Management Structure and Safety Issues Related to the

Neely Nuclear Research Reactor and the

Radiation Safety Program at Georgia Tech

Nicholas Tsoulfanidis, Ph. D., P.E.

Proposed Administrative Structure

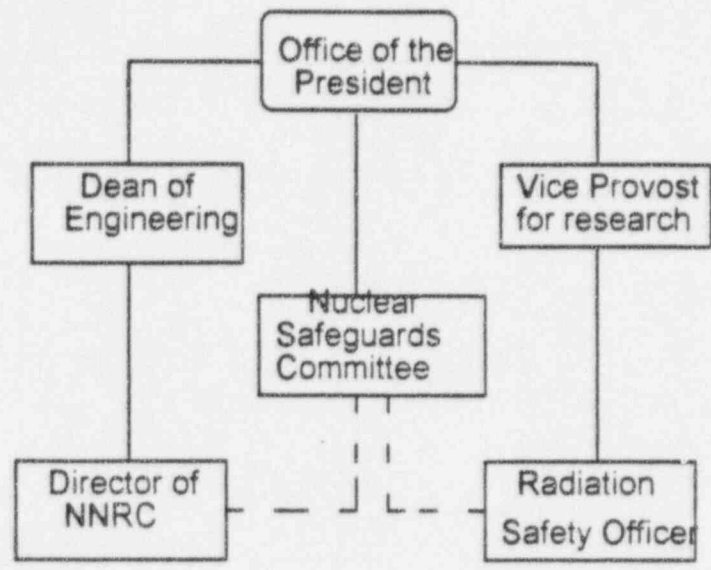
5. The present administrative structure of the Radiation Safety Program seems to work fine and there is no evidence of any kind that safety is compromised. Thus, there is no need to replace the current Director. However, the present reporting method has the potential for errors, omissions, and abuse, particularly if the current Director is replaced and the new one is not so safety-conscious.

To be specific, at present the NNRC Director is also the RSO for the campus. Everybody else reports to him, including the MORS. The Director controls the agenda of the NSC; the director controls all budgets, including that of Health Physics activities. There is no evidence that the current Director either made mistakes or abused the system. However, whenever a program or activity is controlled by a single person the possibility of error or omission of action is possible. For this reason I recommend that the institution change the administrative structure in the following way (see also diagram).

The NNRC Director should report to the Dean of Engineering or equivalent.

The Radiation Safety Officer (or MORS) should report to the Vice Provost for research or equivalent. It is important that the NNRC Director and RSO report to two different persons.

Separate budgets should be set up for the Director of the Reactor and for the RSO.

The RSO will be responsible for Health Physics coverage for the GT campus; the Director of NNRC will be responsible for the safe operation of NNRC and will get Health Physics coverage from the RSO. Both the Director and RSO,

- a. are non-voting members of the NSC; they should be allowed to send their designated representative to a meeting if they themselves cannot be present,
- b. report to the NSC and both contribute to the agenda of the NSC meetings,
- c. in case of differences of opinion between the Director and RSO, differences that are not covered by existing operating procedures, the NSC will resolve the issue.

Diagram used in the calculation of the dose rate from the ^{60}Co source. Dose rate was obtained for point A.

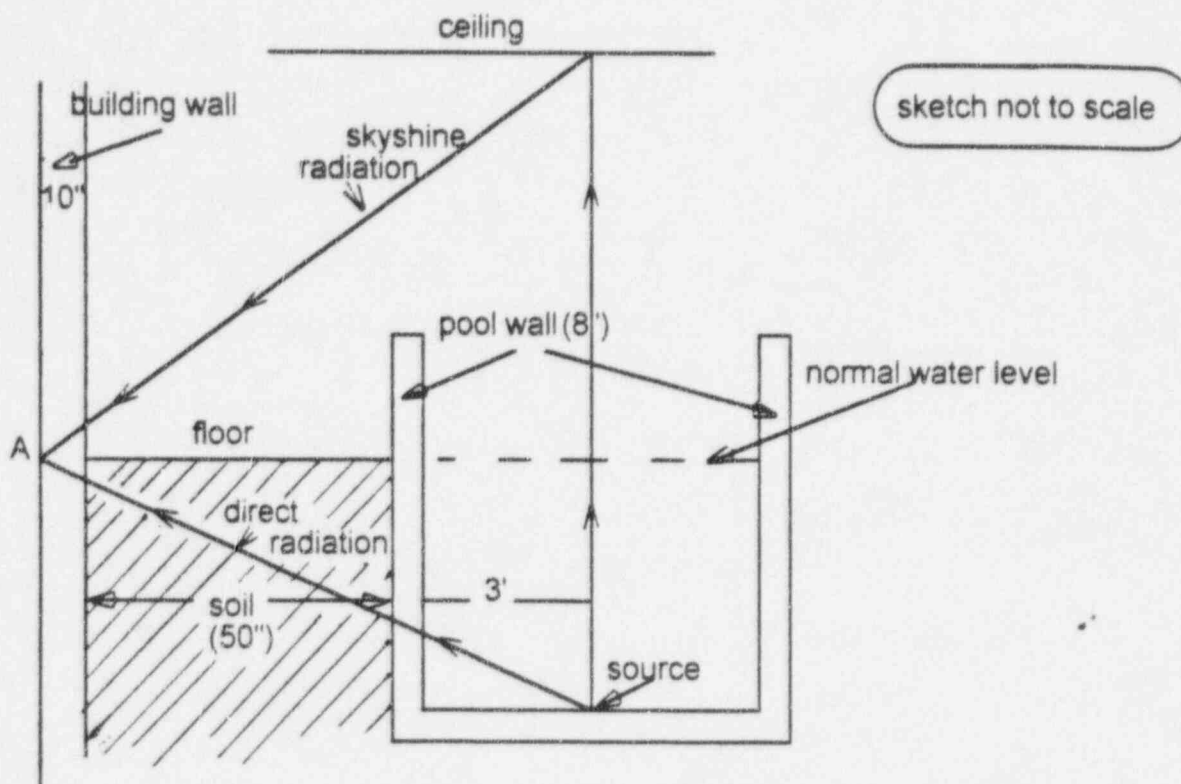
I performed a calculation, using very conservative assumptions, of the dose rate at the outside of the wall of the building, at a point where the highest dose rate would be expected (point A, see sketch). With the water gone, radiation shielding is provided by the wall of the pool, the soil between the pool and the wall, and the building wall itself. I made the following assumptions.

- (i) The source is located at the center at the bottom of the pool.
- (ii) I neglected any self-absorption in the source and attenuation by the air.
- (iii) I assumed all the shielding material to be soil (dirt) with density 1.5 g/cm^3 , i.e. I considered the concrete walls to have that density as well (true concrete density is at least 2.35 g/cm^3).
- (iv) I considered the gamma-ray buildup (from scattering of gammas in the attenuating medium).
- (v) I considered 'skyshine' radiation, i.e. gammas that hit the ceiling of the building and are scattered back towards the point of interest. I made the very conservative assumption that 3% of the gammas hitting the ceiling are reflected back towards the outside wall.

The result of the calculation is:

Direct dose rate is about 3×10^{-6} mrem/h

Dose rate from skyshine is about 6×10^{-5} mrem/h

It should be mentioned that the background radiation level should be about 0.01 to 0.03 mrem/h (excluding radon). Thus, even under the most conservative assumptions, with the loss of water in the pool, a person could standing close to the outside wall would receive less than 1% of the background radiation that exists everywhere and is received by every person anywhere.

Based on this calculation, I do not consider it necessary to have the already existing fence around the NNRC replaced or reinforced ; a new fence would just attract attention and raise questions without increasing safety.
